Addendum 2

RFQMA24 – 5030

Glenforest Secondary School City of Mississauga

Pool Demolition

Graphic Scale		Sheet no.
AS SHOWN		E5
Drawn RS	Checked SS	
CAD File -	Scale AS NOTED	Revision No.
Date DECEMBER 2022	Project No. 23-124

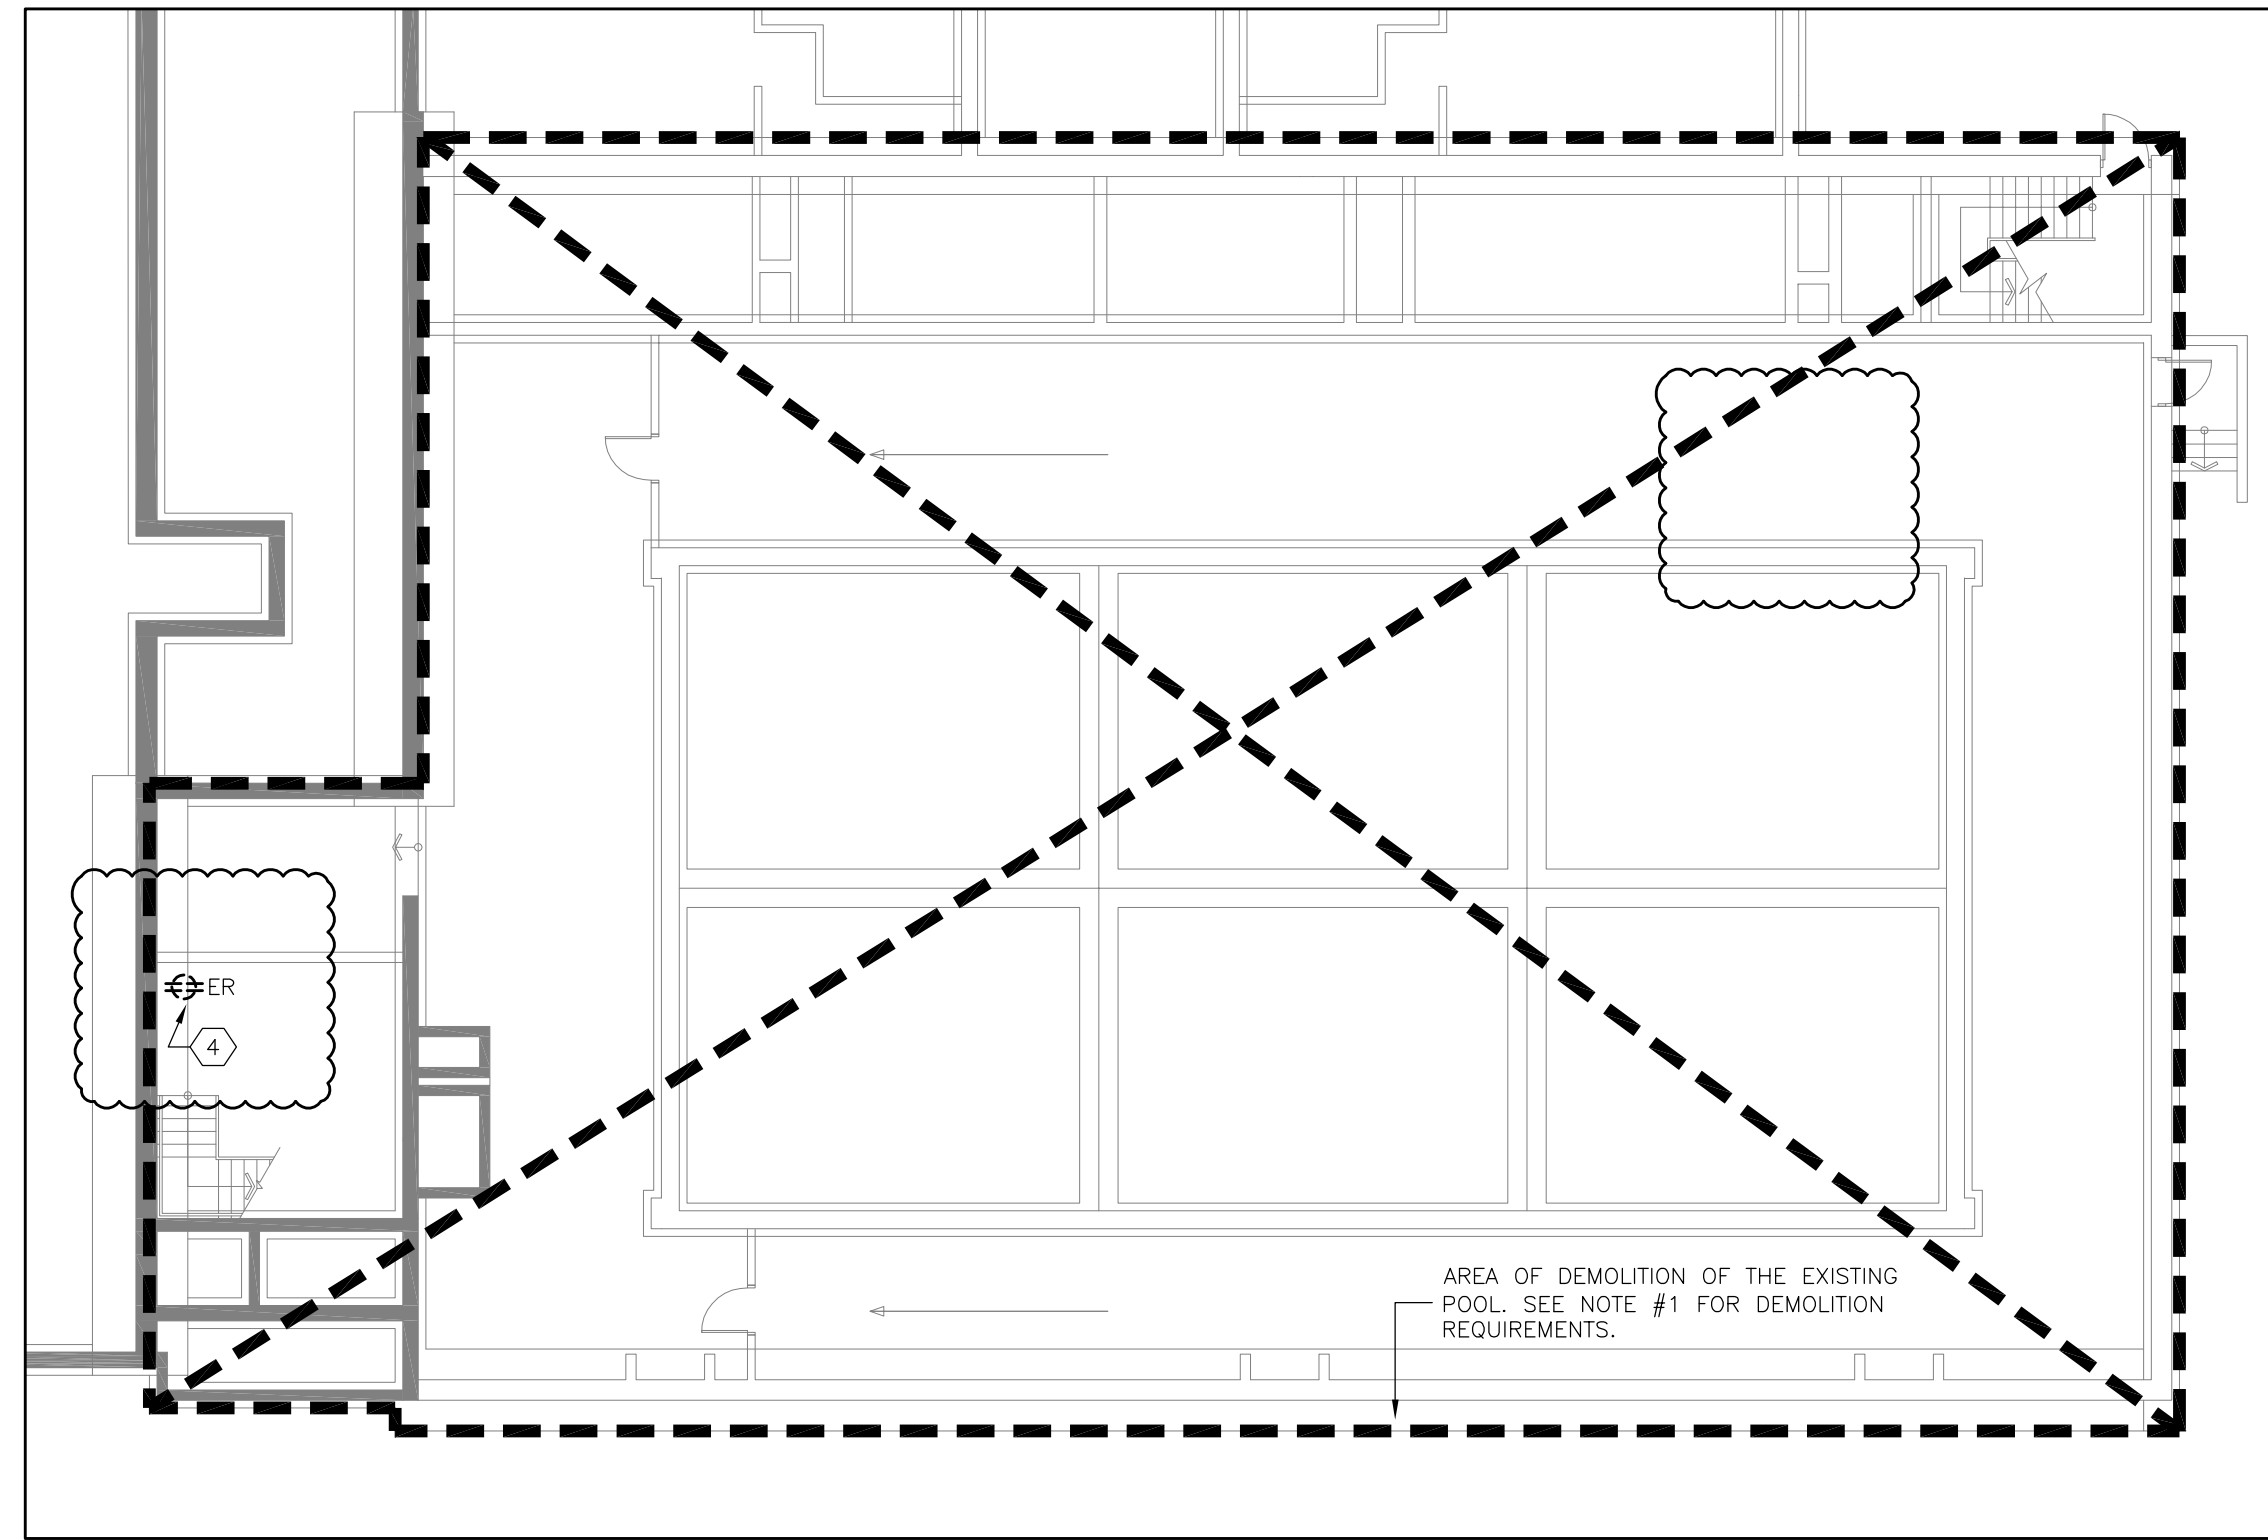
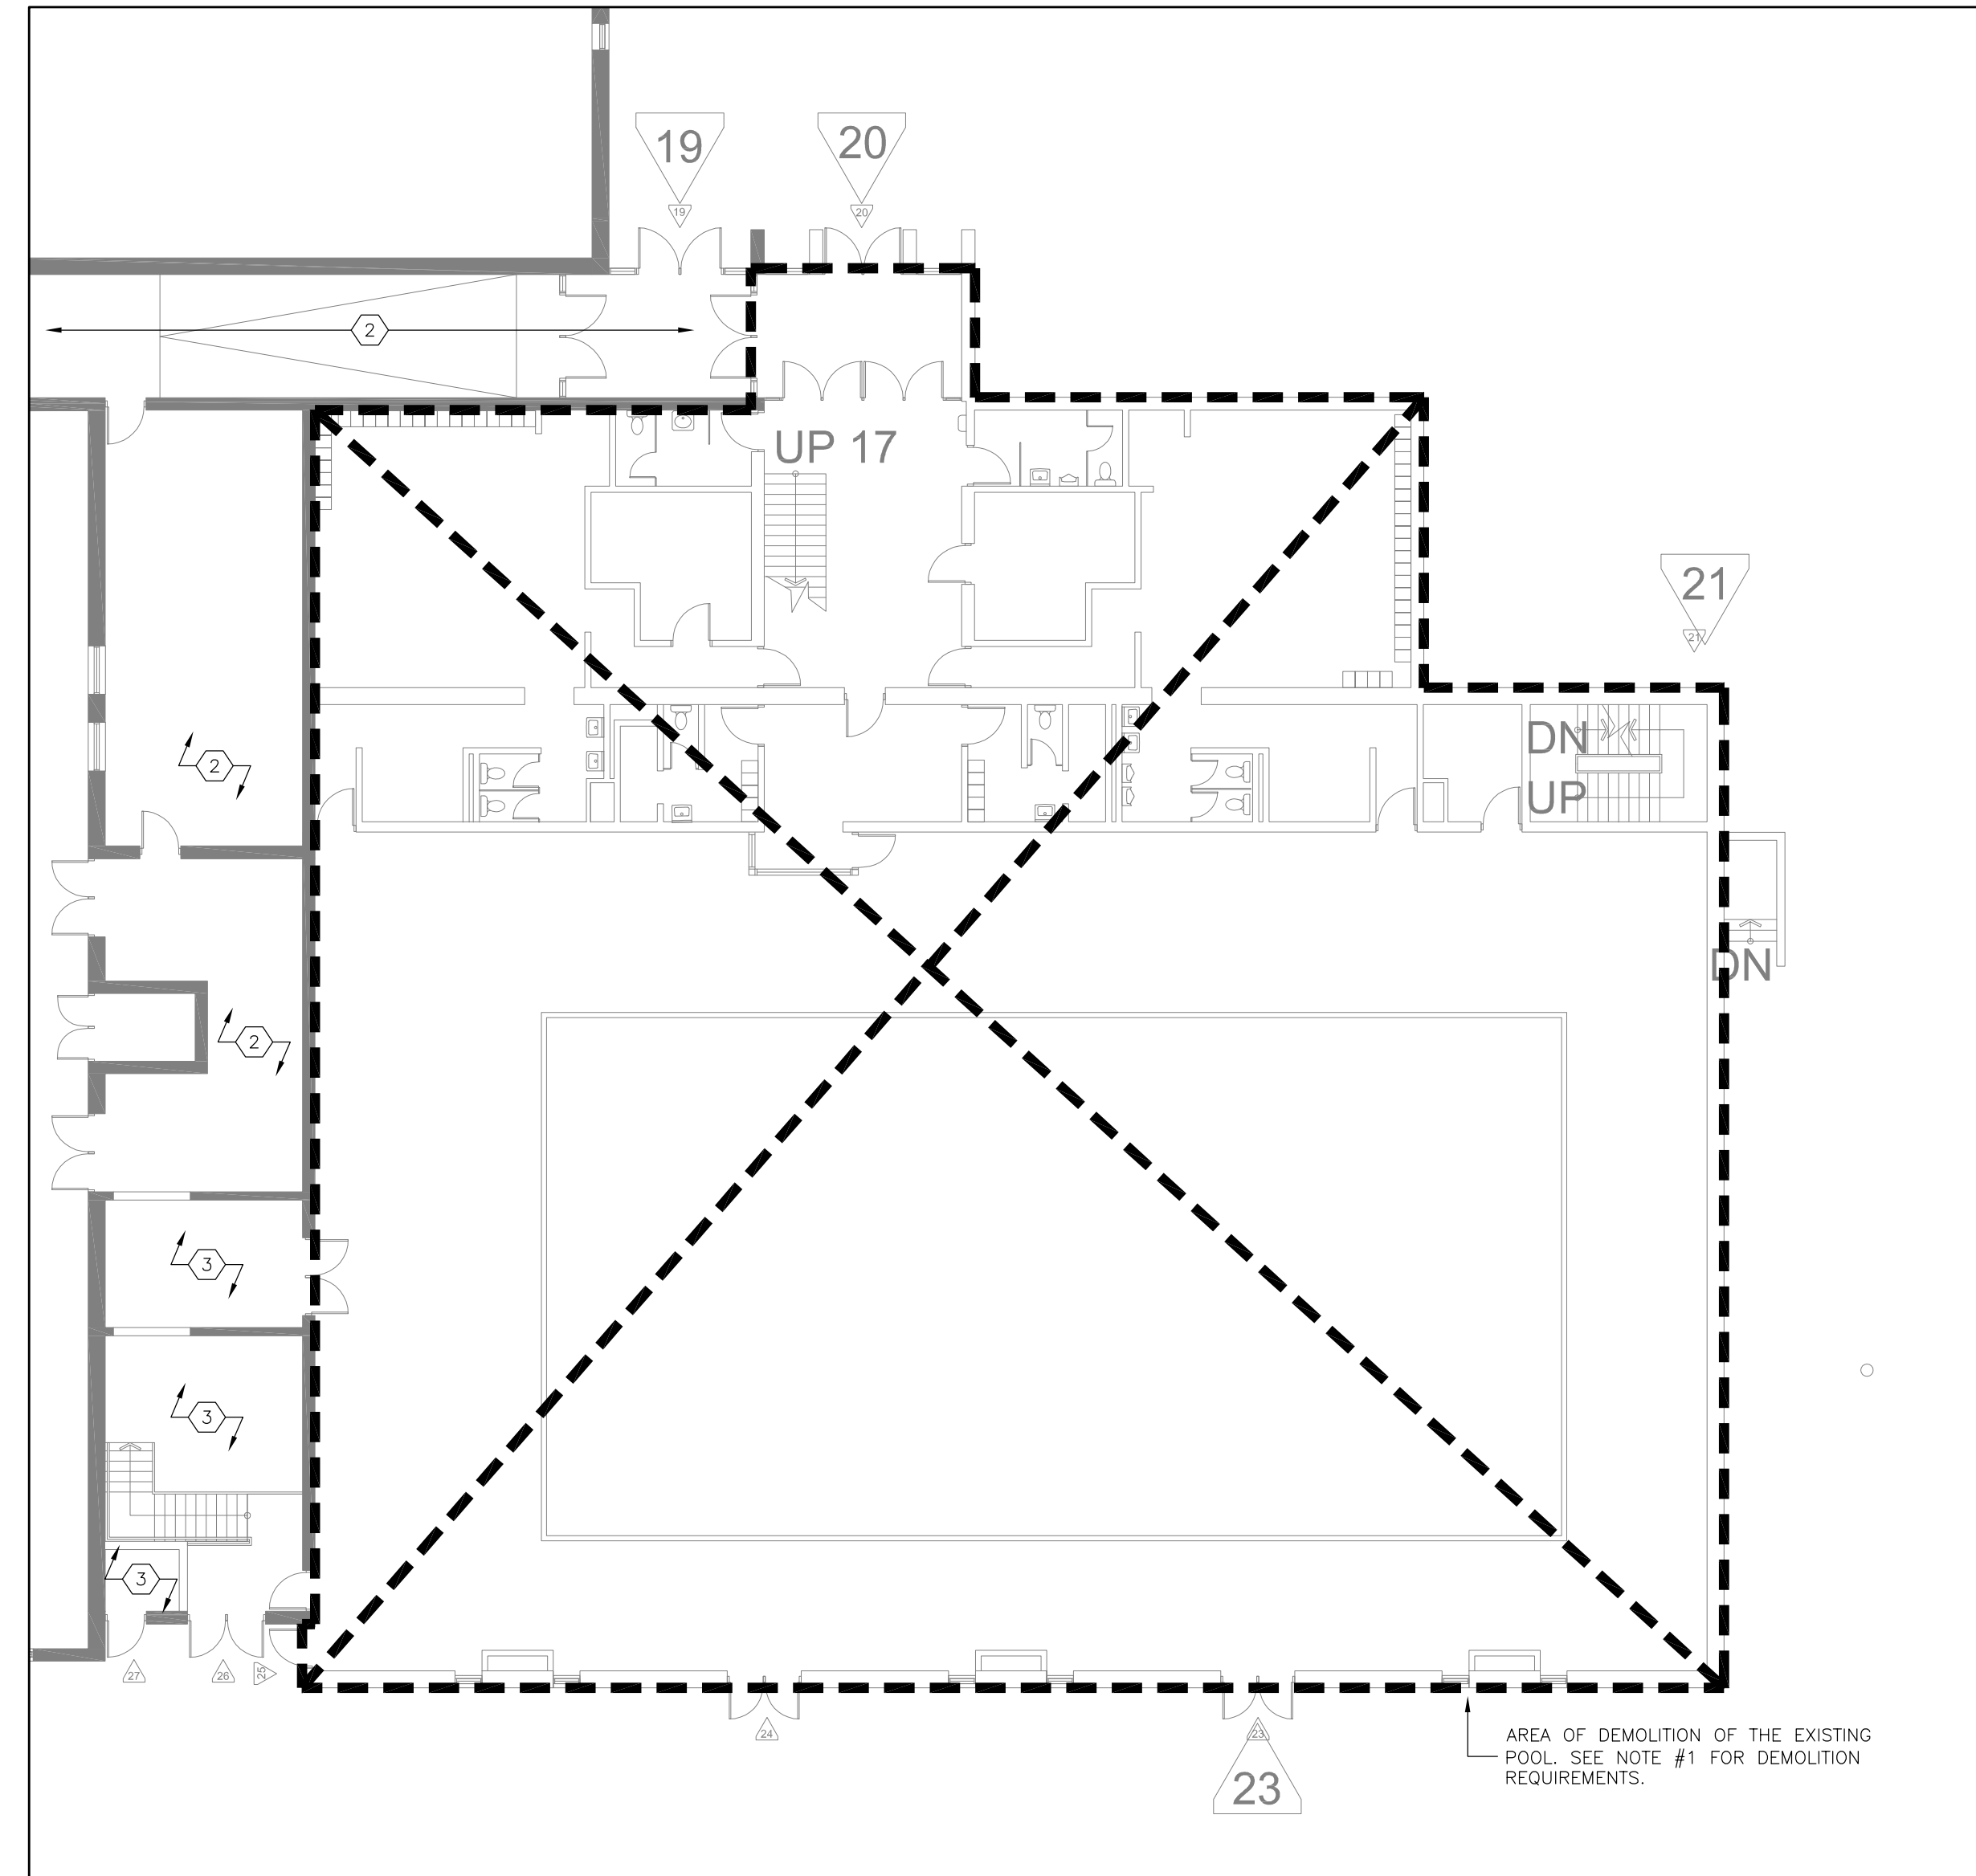
- 2.2.1. Refer to Mechanical Addendum no. M&E#1
- 2.3. Refer to note 4 on E5. GC to provide routing for conduit and wiring for relocated GFI Outlet. Location of outlet to be relocated to gym storage room. Exact location to be determined on site. See note 215 on A201, and note 284 on A202. Trace wire to panel, and refeed from panel.

1. See attached re-issued Drawing with Clouded Revisions.
